ON SITE HOMES
DAUGHTRY-II
DRIVE RIGHT

CELEBRATIONS

A-3

FIRST FLOOR
PLAN
A-5

FRONT ELEVATION-C
SCALE: 1/4" = 1'-0"

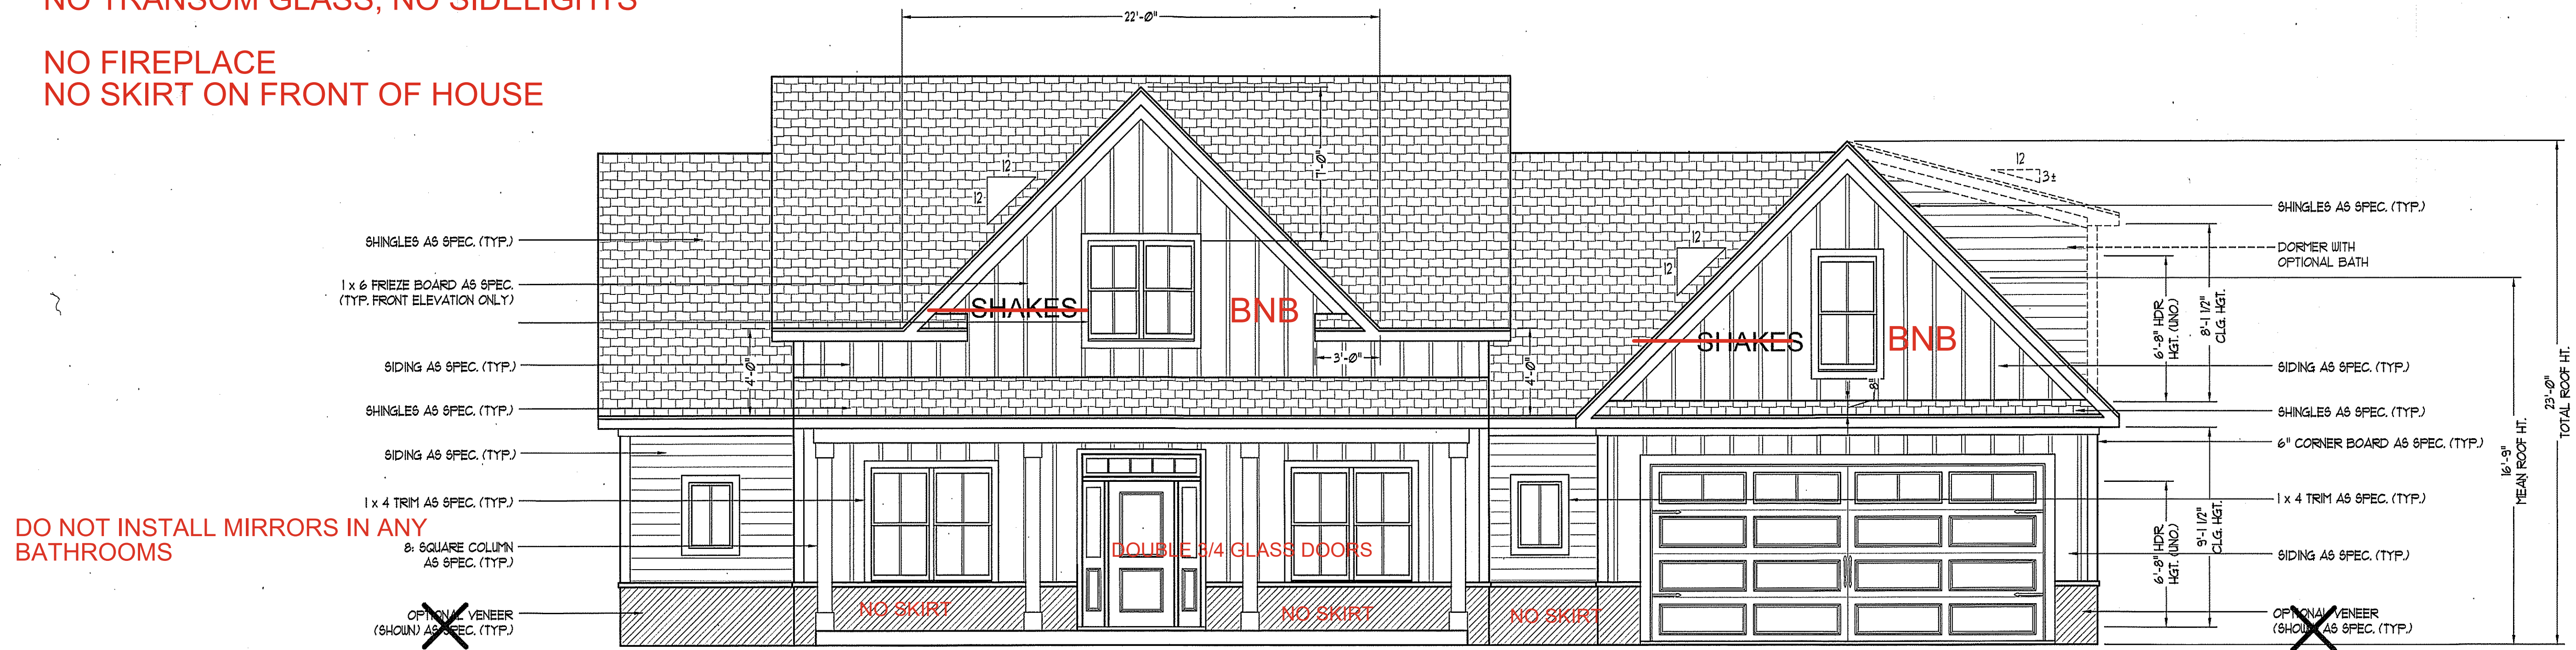
NO FIREPLACE
NO SKIRT ON FRONT OF HOUSE

DO NOT INSTALL MIRRORS IN ANY BATHROOMS

BNB IN FRONT ELEVATION GABLES

~~SHAKES IN FRONT ELEVATION GABLES~~
VAULTED FAMILY ROOM CEILING
HOSE BIB LOCATIONS ON NEXT PAGE
COFFERED CEILING IN DINING ROOM
UPSTAIRS BATH; FIBERGLASS SHOWER/NO TUB

PROPANE TANKLESS WATER HEATER

~~ELECTRIC TANKLESS WATER HEATER~~
SEE SPEC SHEET FOR SPECIFIC MASTER BATH TUB
VENT HOOD TO EXTERIOR OF HOUSE
72X80 GLASS SLIDER IN BEDROOM #4 INSTEAD OF WINDOWS
ADD 72X80 GLASS SLIDER IN MASTER BEDROOM
ADDITIONAL BAR SINK; SS; UNDERMOUNT

(2) FAUCETS IN KITCHEN TO BE CHAMPAGNE BRONZE FINISH

ADD WALLS TO DINING TO CLOSE IT IN; ADD FRENCH DOORS GOING INTO DINING

(4) recessed lights in family room cathedral ceiling

INSTALL GENERAC GENERATOR AND RUN GAS LINE FOR IT

INSULATE BEDROOM 3 INTERIOR WALLS

50 AMP PLUG AND POSSIBLE SEPTIC FOR RV
ON RIGHT SIDE OF GARAGE
BLACK WINDOWS AND SLIDERS
WHOLE HOUSE/ WRAP GUTTERS
CERAMIC TILE SHOWER IN DOWNSTAIRS GUEST BATH
INSULATE MASTER BEDROOM INTERIOR WALL
FRAMELESS MASTER SHOWER DOOR
BLACK GARAGE DOOR PER PLAN

(1) OUTLET KITCHEN PANTRY SOUTH SIDE; (1) OUTLET BONUS ROOM WALK IN CLOSET BACK WALL; (1) EXTRA OUTLET IN KITCHEN UNDER ADDITIONAL CABINETS FOR UNDERCABINET DRINK FRIDGE

INSTEAD OF FIREPLACE PUT ELECTRICAL OUTLET DOWN LOW WITH ARLINGTON BOX UP HIGHER; HEIGHT YOU WOULD PUT IT IF THERE WAS A FIREPLACE THREE

(1) ADDITIONAL OUTLET ON EXTENDED PORCH; (1) EXTERIOR OUTLET TO THE SIDE OF THE MASTER BEDROOM REAR SLIDER DOORS

EXTEND MASTER SHOWER TO 42" DEEP WITH BENCH

REAR ELEVATION
SCALE: 1/8" = 1'-0"

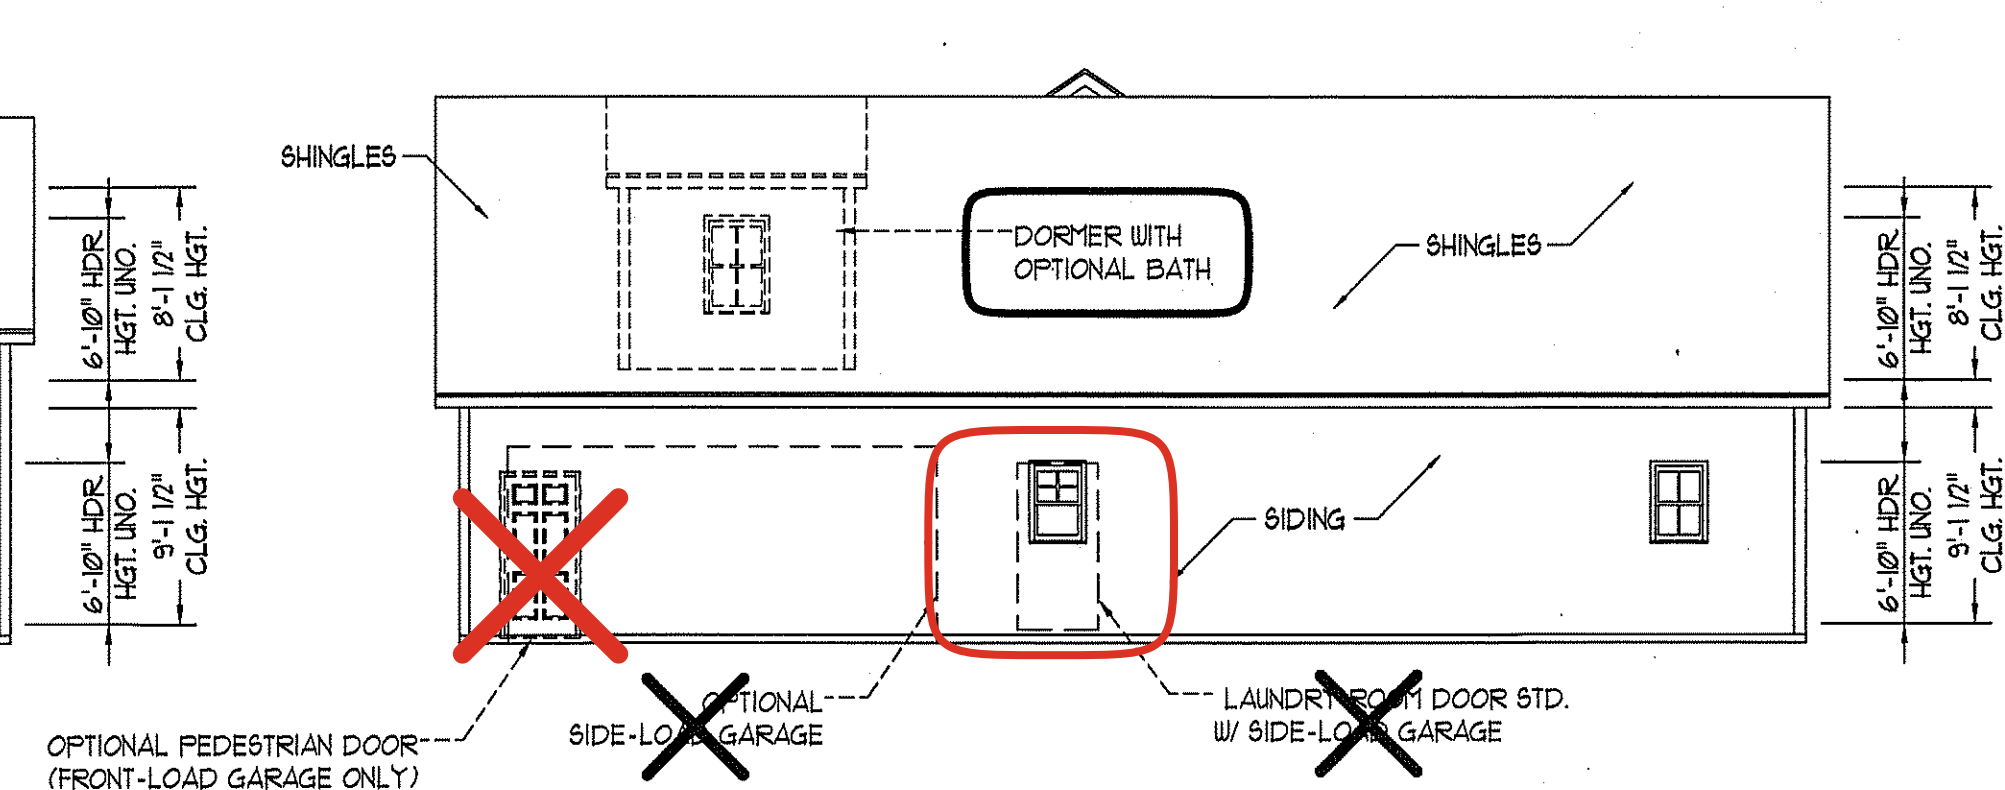
YES TO DOOR OFF LAUNDRY

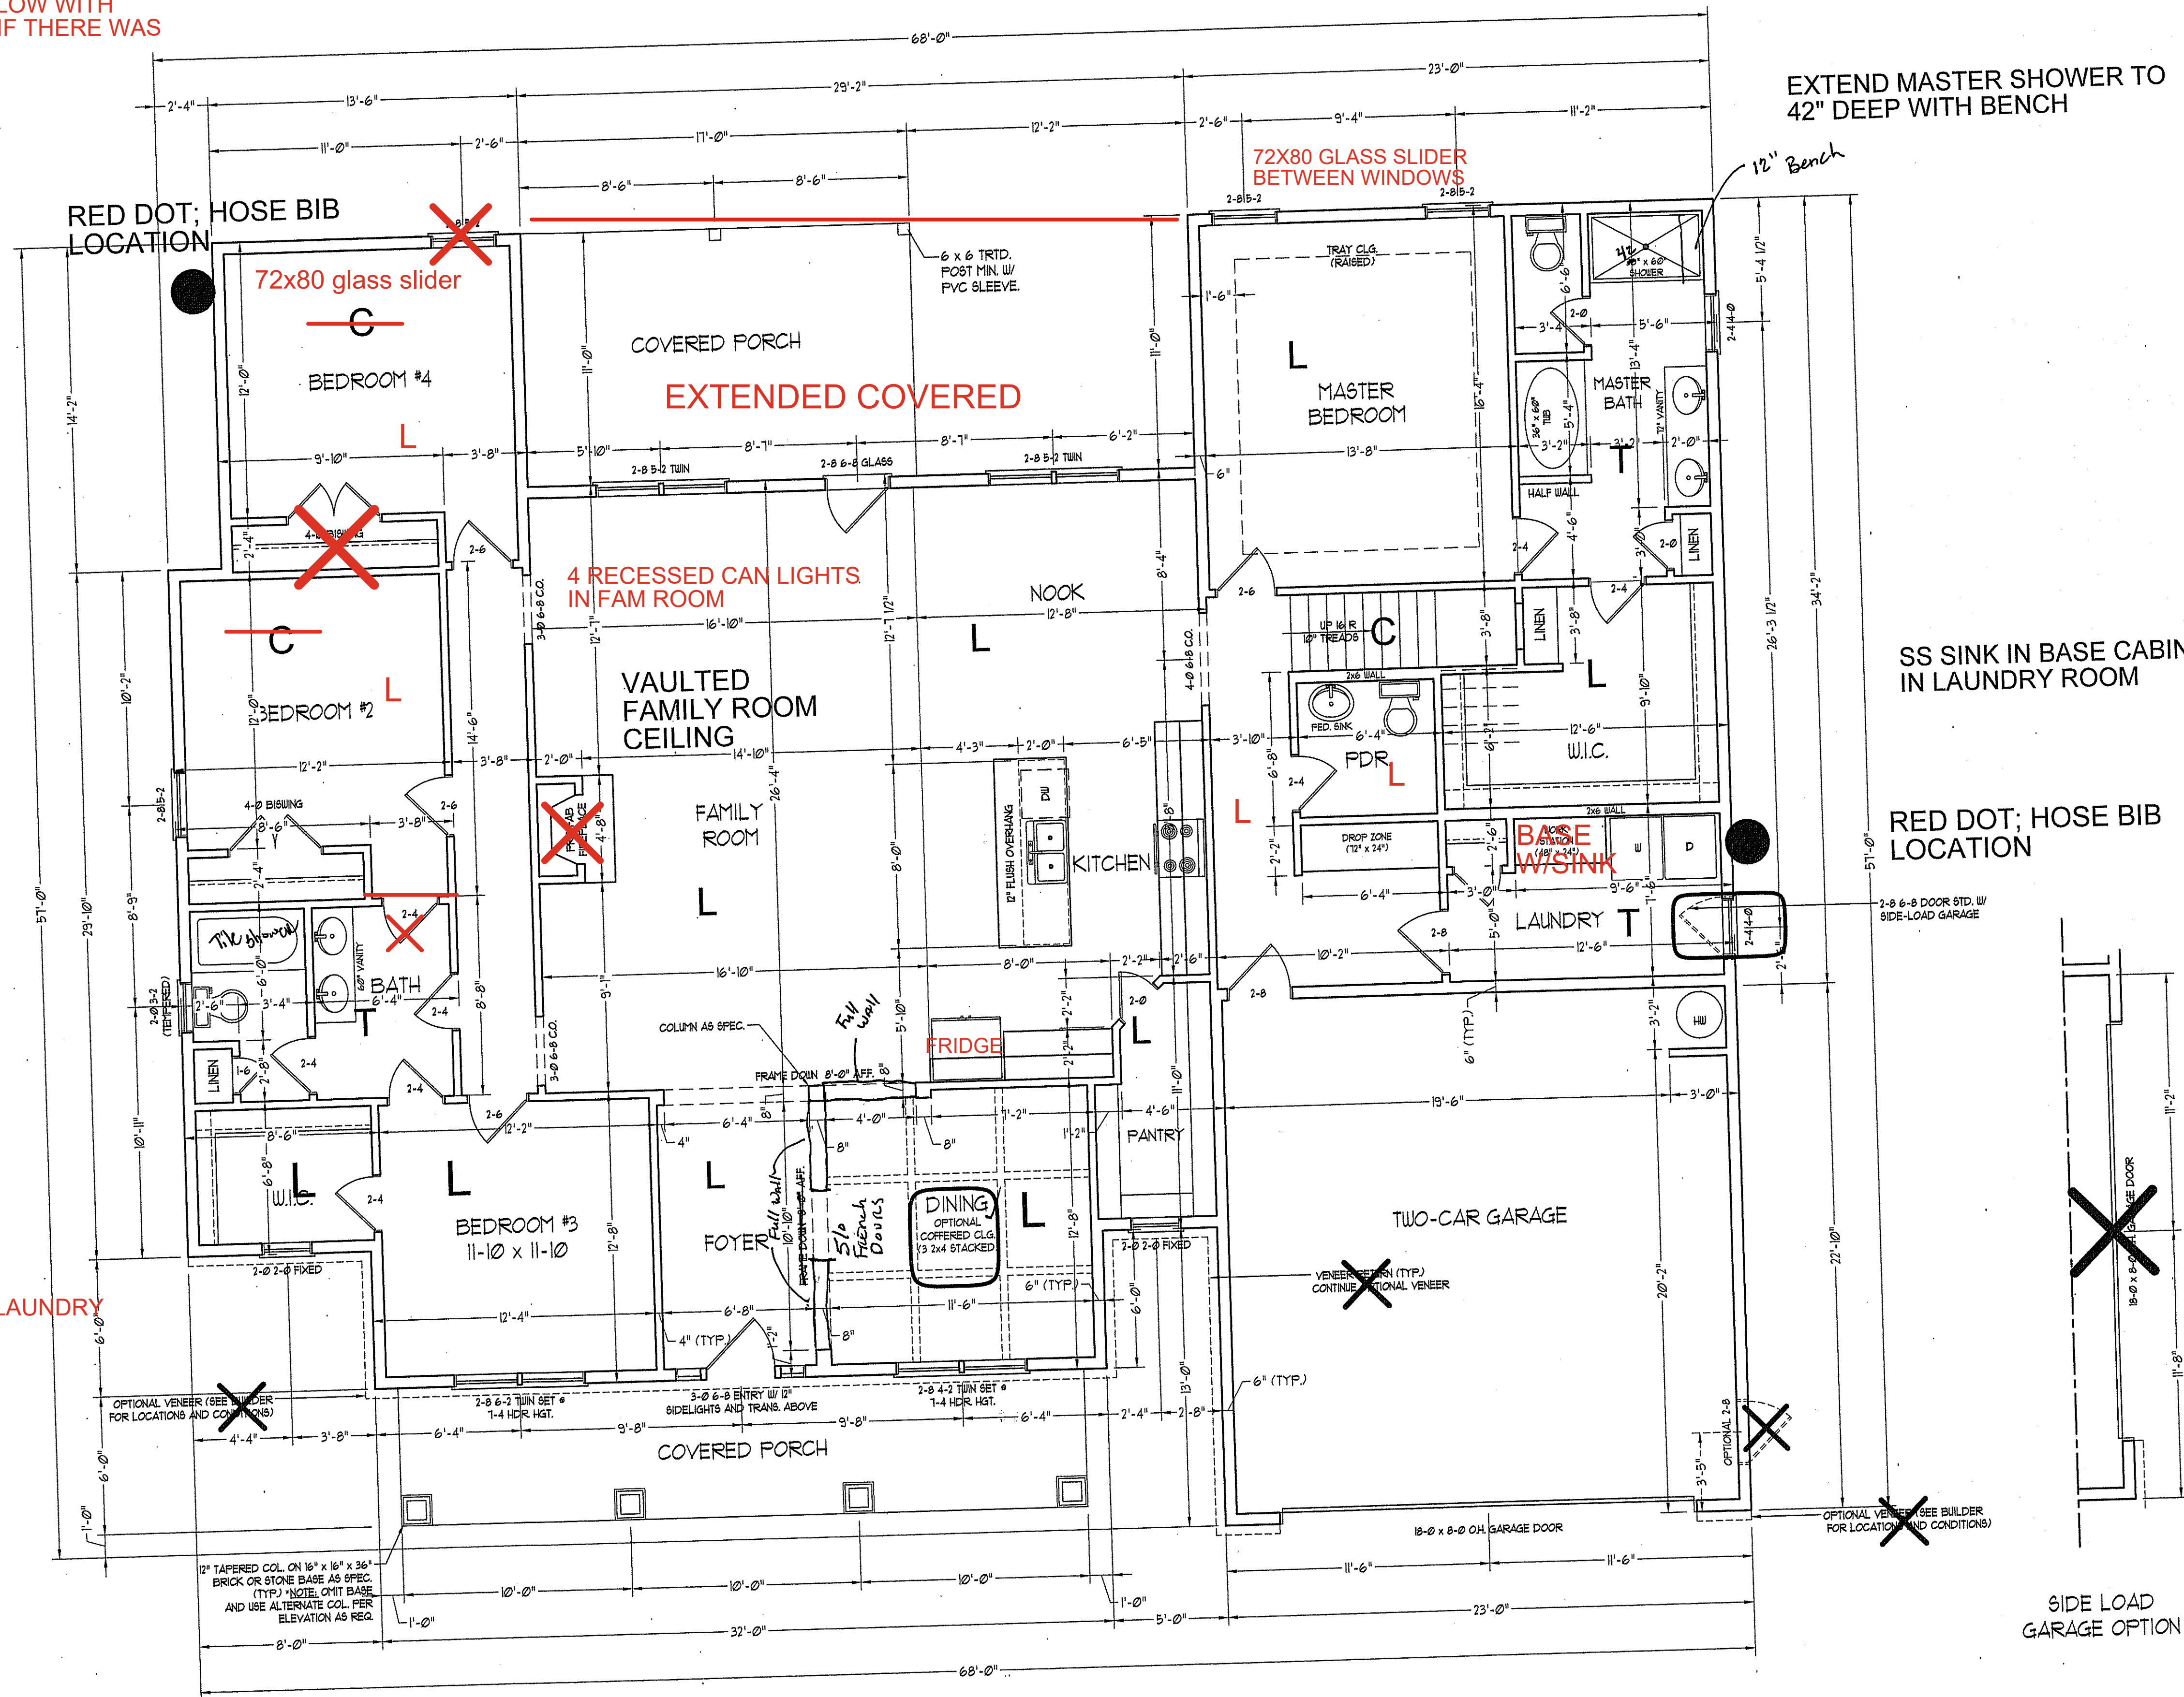
ADD WALLS TO CLOSE IN DINING;
ADD FRENCH DOORS GOING INTO DINING

NO CLOSET IN BED #4

NO CARPET DOWNSTAIRS
CABINETS ON BOTH SIDES OF FRIDGE
BASE CABINET WITH STAINLESS UNDERMOUNT SINK IN LAUNDRY
INSTEAD OF WORK STATION

NO DOOR BETWEEN BED#2 AND BATHROOM
TILE BENCH IN DOWNSTAIRS GUEST BATH

BASE CABINET WITH SMALL SS BAR SINK IN KITCHEN
BETWEEN PANTRY AND FRIDGE
